ADDENDUM NO. 03
04 June 2010

Project: **ALLIED HEALTH ADDITION @ CENTRAL CAMPUS**
San Jacinto College District

Bay Project No.: **0822**

ADD-03-SKE6
 0822
 1/8"=1'0"
 06/04/2010
 E1102

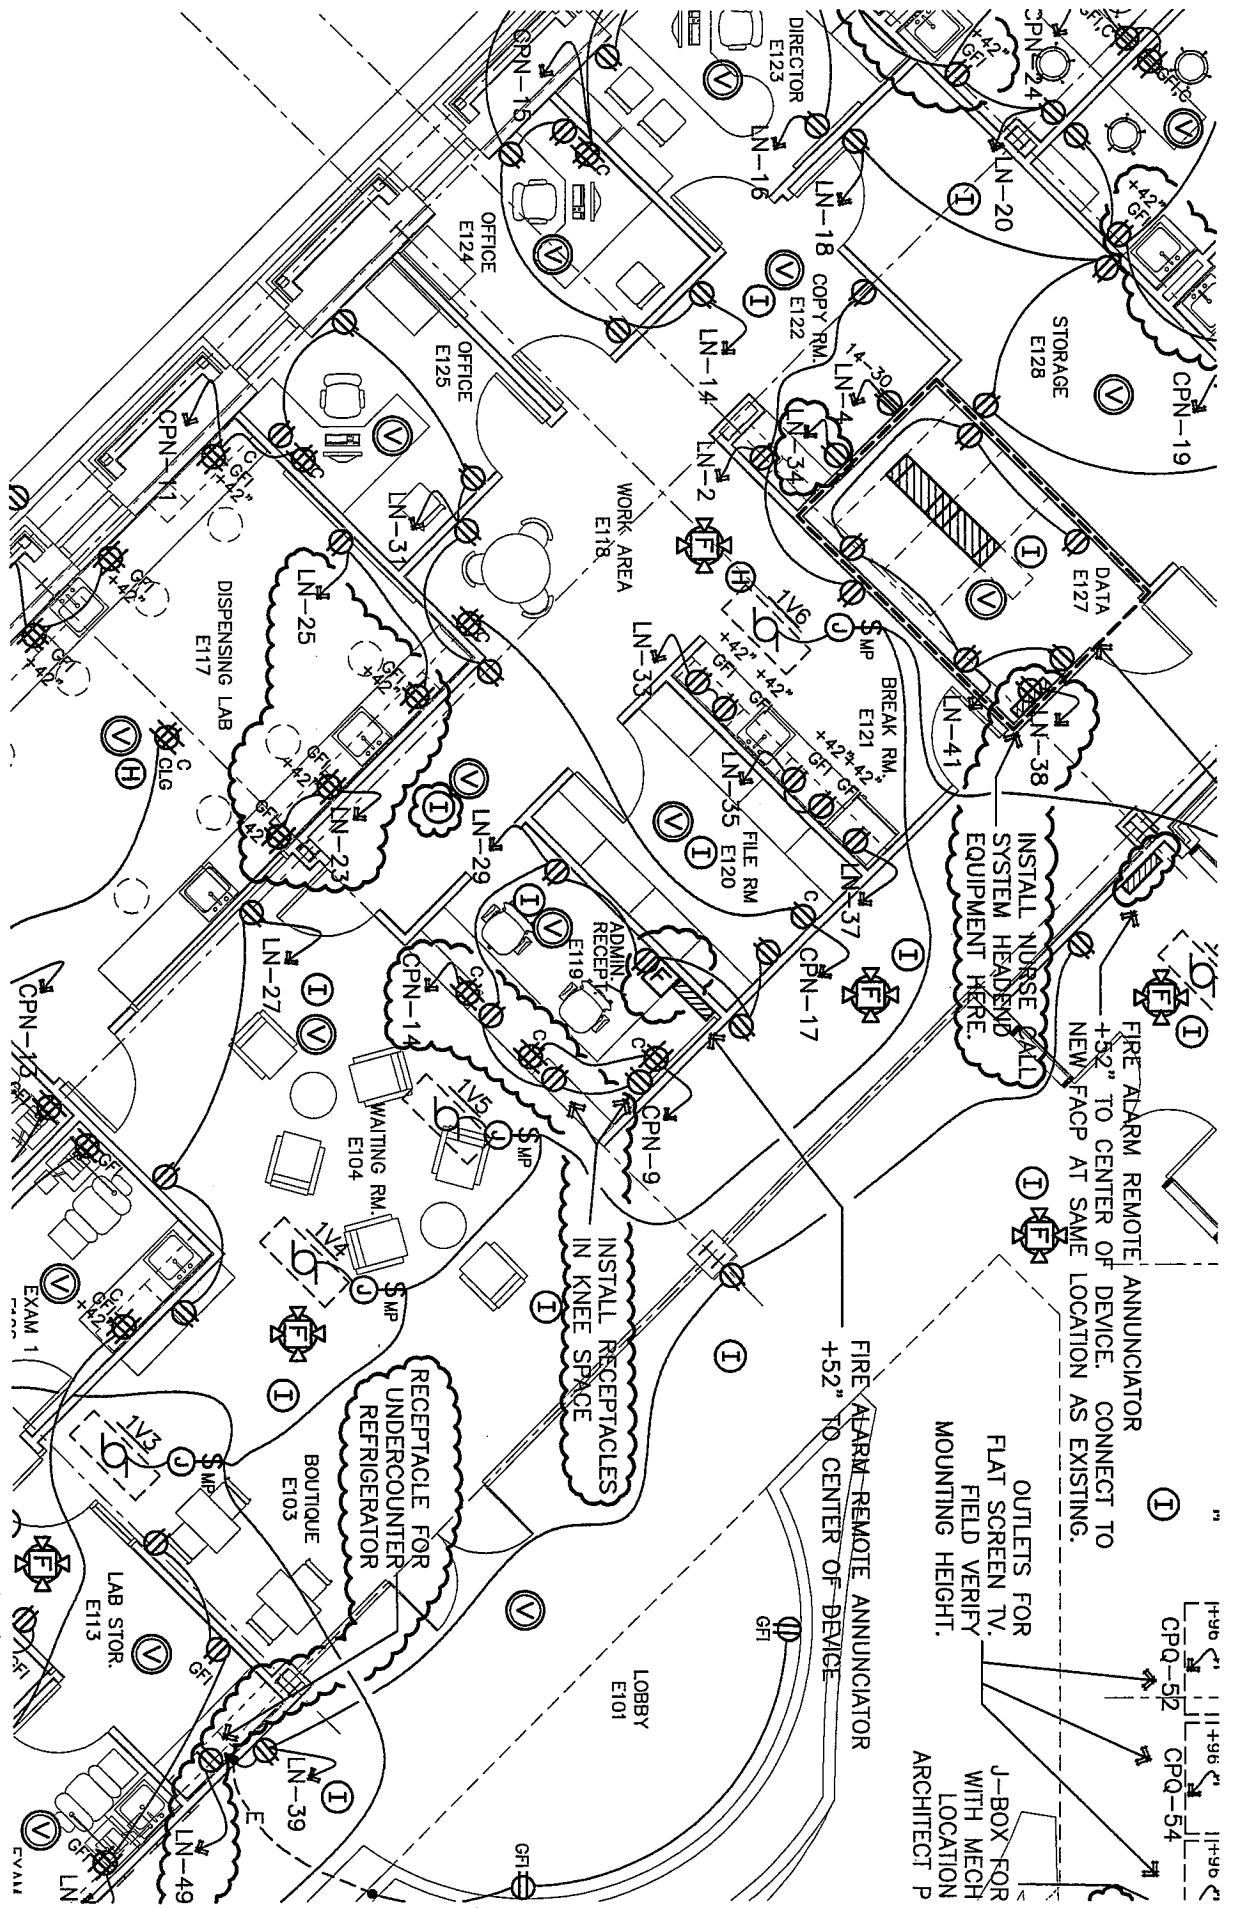
- 2)
 - 3) . Add note to read "Receptacle for undercounter refrigerator. See attached **DRAWING ADD-03-SKE6. I**
 - 4) Relocate ceiling fire alarm devices to be roughly centered in room.

- j. Dispensing Lab E117:
 - 1) On upper right wall, delete receptacle lowest on wall with home run tag to circuit LN-25. Revise remaining three receptacles on that wall from duplex to quad devices. Connect two lowest back to circuit LN-25. Leave uppermost receptacle connected to receptacle on upper wall on LN-23. See attached **DRAWING ADD-03-SKE6. I**

- m. Copy Room E122: Break circuit connecting 20A receptacle adjacent to 14-30 receptacle to three other receptacles on circuit LN-2. Place this receptacle on dedicated circuit LN-34 for copy machine. See attached **DRAWING ADD-03-SKE6**.

ADD-03-SKE7

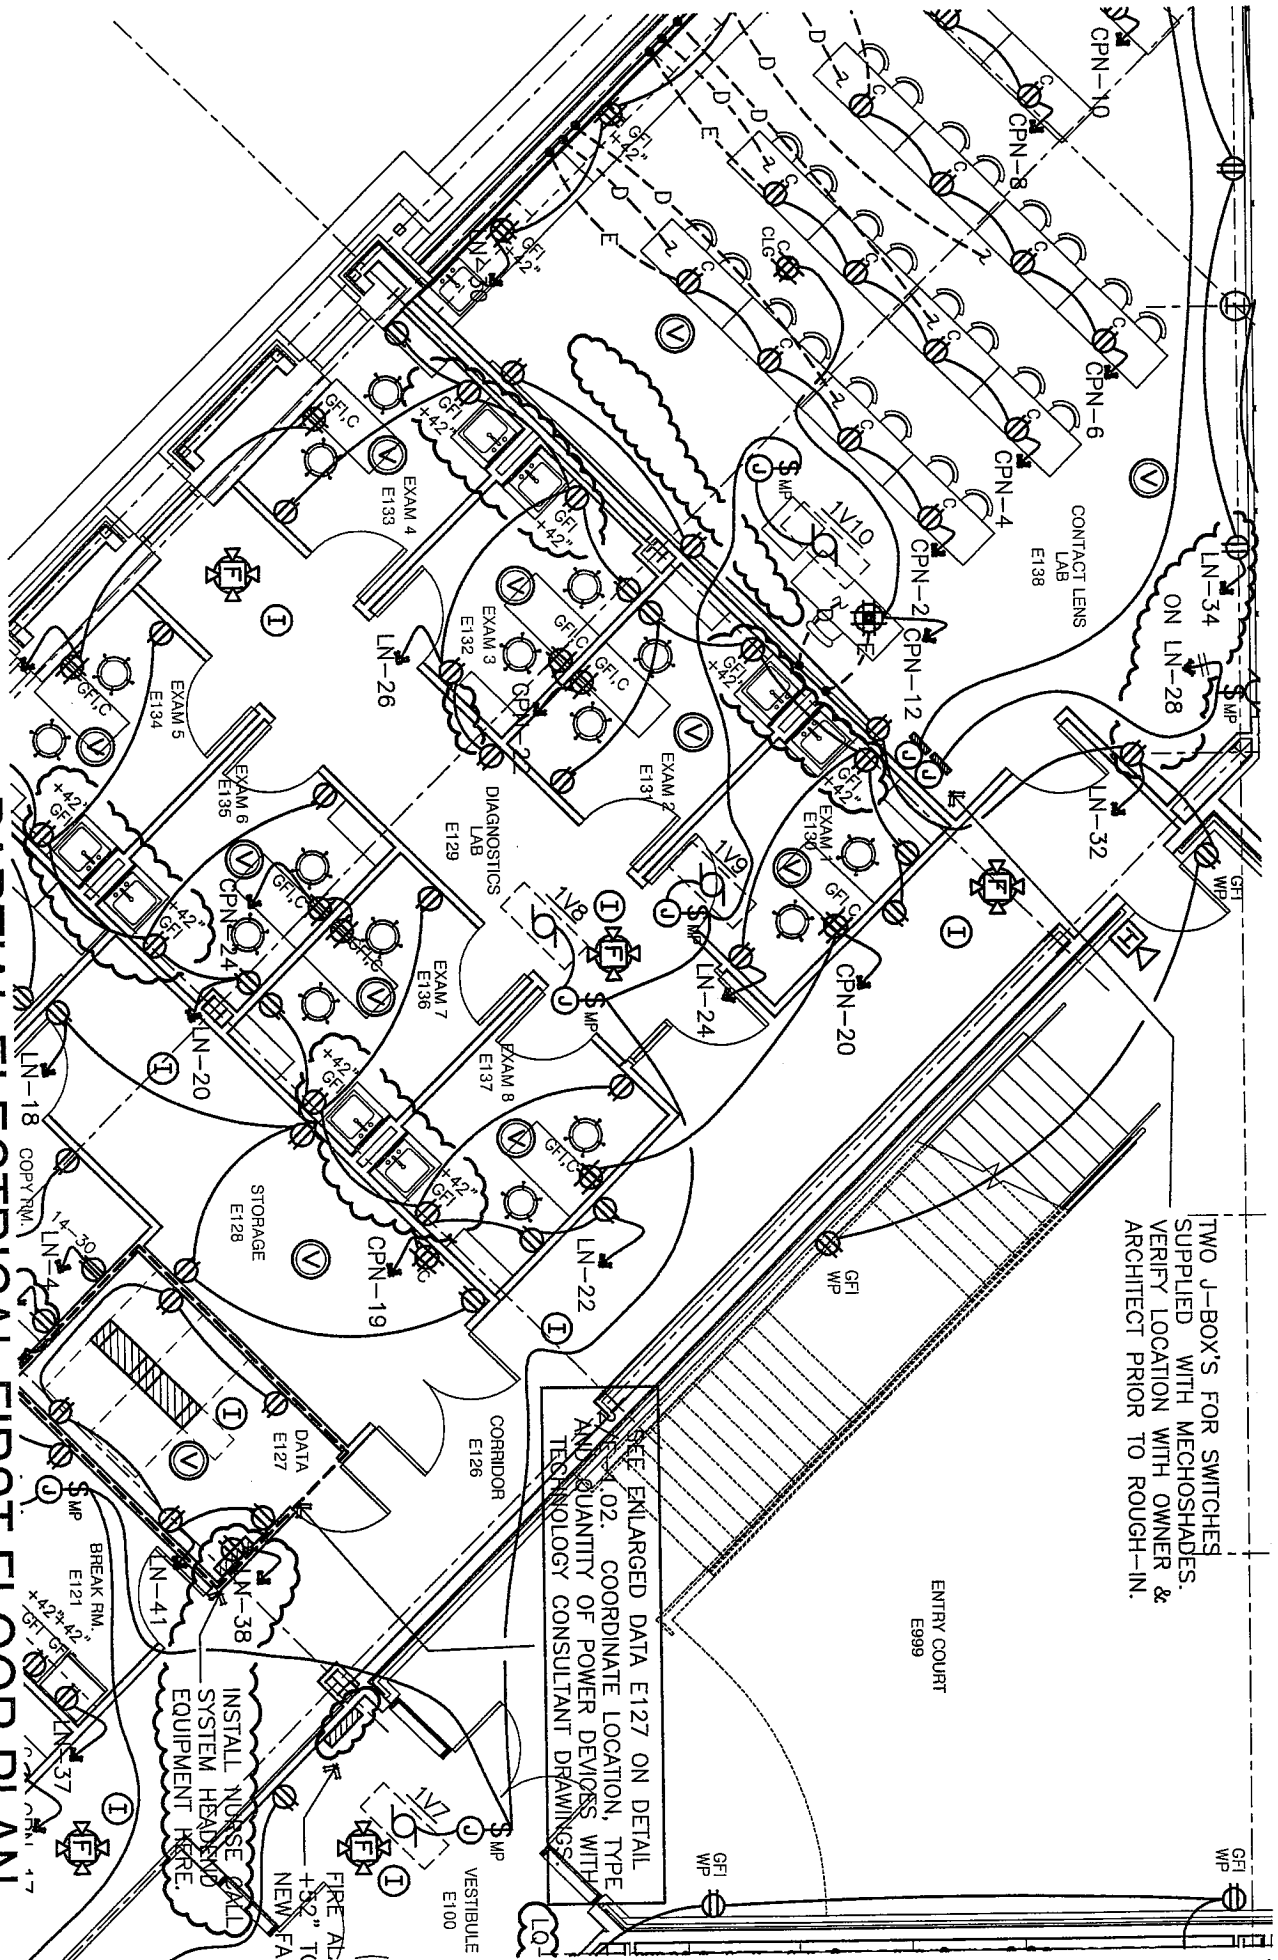
- o. Diagnostics Lab E129: Connect receptacle on upper left wall just above room name tag to circuit LN-26. See attached **DRAWING ADD-03-SKE7**.
 - p. Exam Rooms E130, E131, E132, E133, E134, E135, E136, and E137:

- 1) Relocate receptacle at sink in each exam room to location on same wall slightly away from sink. All should be GFI type mounted at standard height. See attached **DRAWING ADD-03-SKE7**.

- q. Contact Lens Lab E138:
 - 1) Break circuit connecting 20A receptacles on upper wall with exterior receptacle in Entry Court E999. Receptacles on upper wall and upper left corner walls are placed on new circuit LN-40. Remaining receptacles are left on LN-32. See attached **DRAWING ADD-03-SKE7**.

ADD-03-SKE8

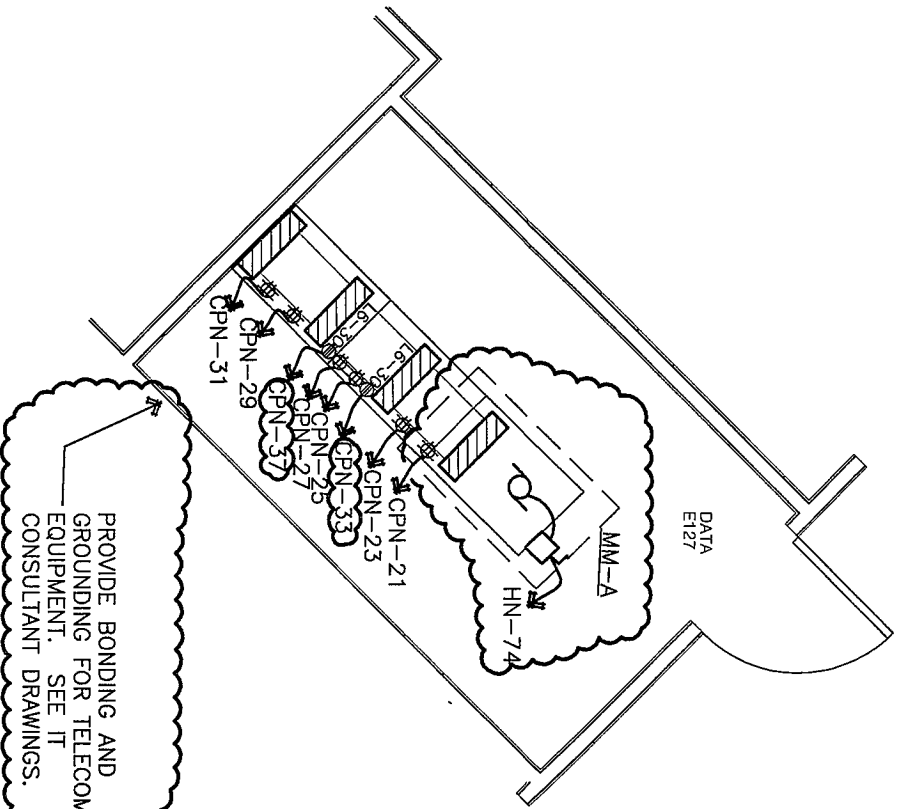
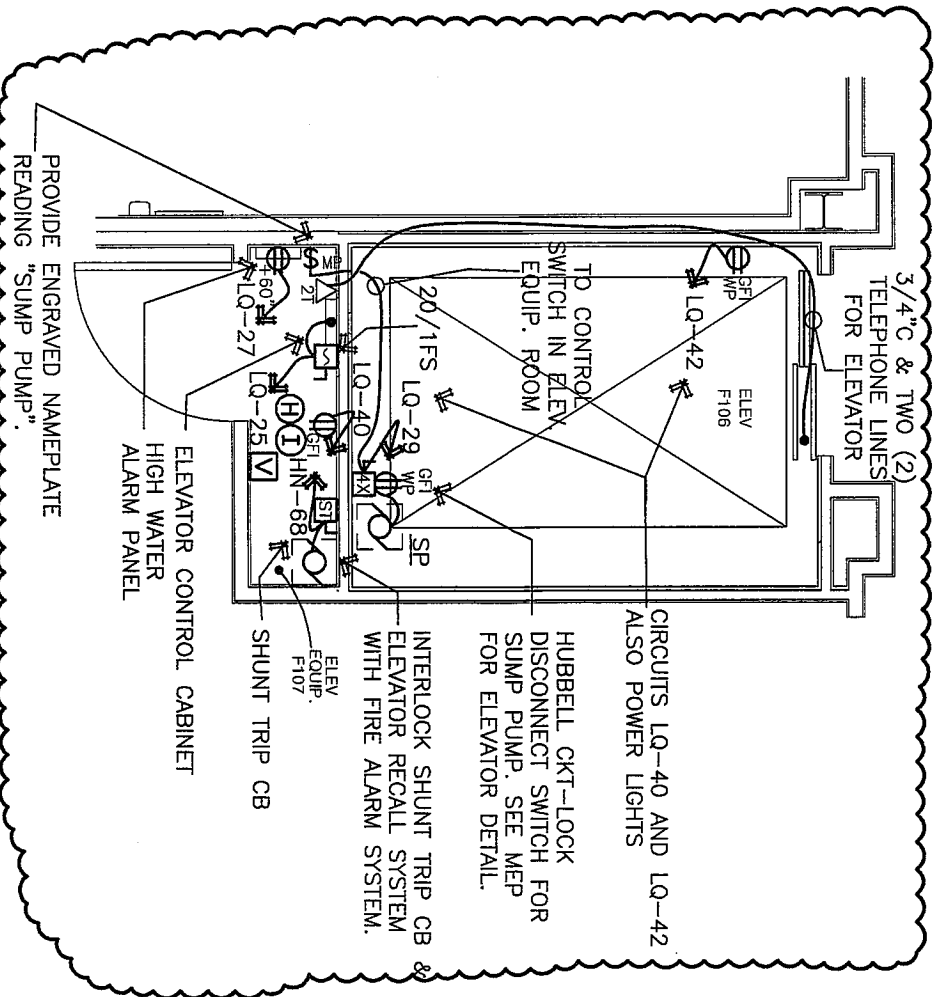
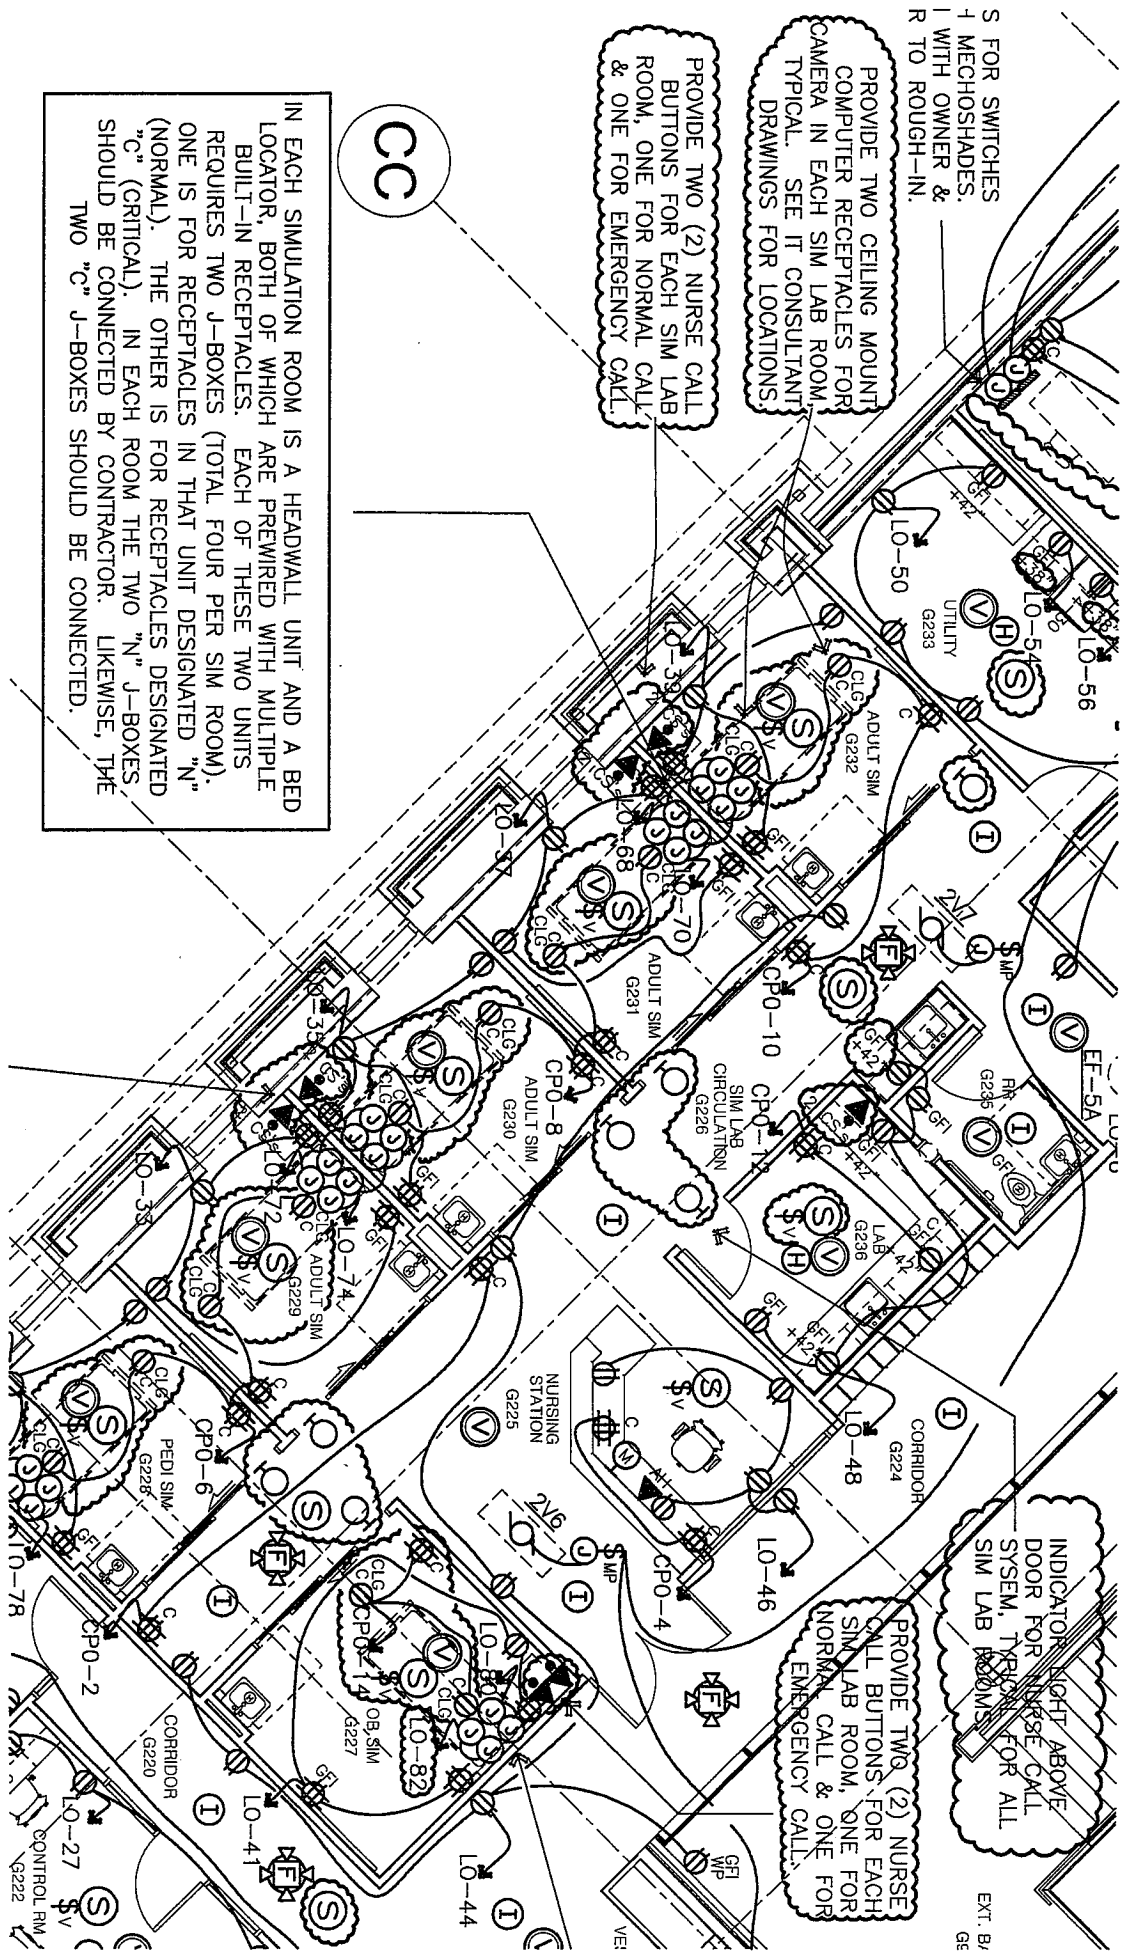
- 5) Add note to read, "Provide bonding and grounding for telecom equipment. See IT consultant drawings." For all above items for this room, see attached **DRAWINGS ADD-03-07 and ADD-03-SKE8**.

- 2) Relocate starter and disconnect switch for FCU-F on circuit HN-38 to opposite wall between Panel LQ and starter for AHU-F. Also, revise starter for FCU-F to VFD type.
 - 3) Add Fire Sprinkler Riser in upper right corner of room near door and add the following note, "Interlock Fire Sprinkler Riser with Fire Alarm System".
- v. Elevator F106 & Elev. Equip F107: New devices and circuits have been added to both rooms. Add Detail 3 on Sheet E1.02 titled, "Enlarged Elev. F107 & F108 Elec. Floor Plan". See attached **Drawing ADD-03-SKE8**.

SEE ENLARGED DATA E127 ON DETAIL E1.02. COORDINATE LOCATION, TYPE AND QUANTITY OF POWER DEVICES WITH TECHNOLOGY CONSULTANT DRAWINGS.
